PRODUCT
SUPPORT
BULLETIN # 407

48-05-1005 1-1/4" - 3" Sharp-Fire® Magazine

6708-20, 6708-51, 6708-56 1-1/4" - 3" Sharp-Fire® Screw-Shooter System

SUBJECT: difficulty driving 3" screw - 43-46-0208 Depth Control

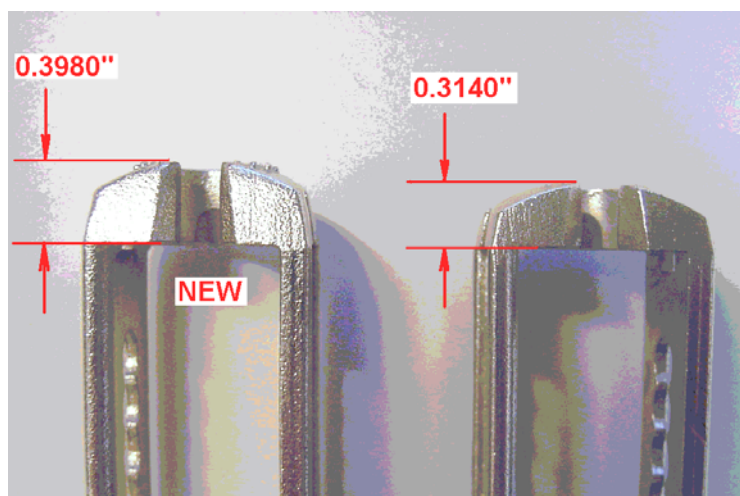
A running change has been made to the 43-46-0208 Depth Control Bracket [fig.30] adding roughly 5/64" of material (*see photo*) to the nose of the barcket to eliminate the problem with difficulty in driving 3" screws.

The difficulty being that the tip of a 3" screw comes in contact with the work surface before being properly positioned / aligned in the bracket, not allowing for a 3" screw to be driven into the work.

A 43-46-0208 Depth Control bracket with a 0.3140" nose height measurement should be replaced with a 0.3980" Depth Control bracket at no-charge - under warranty.
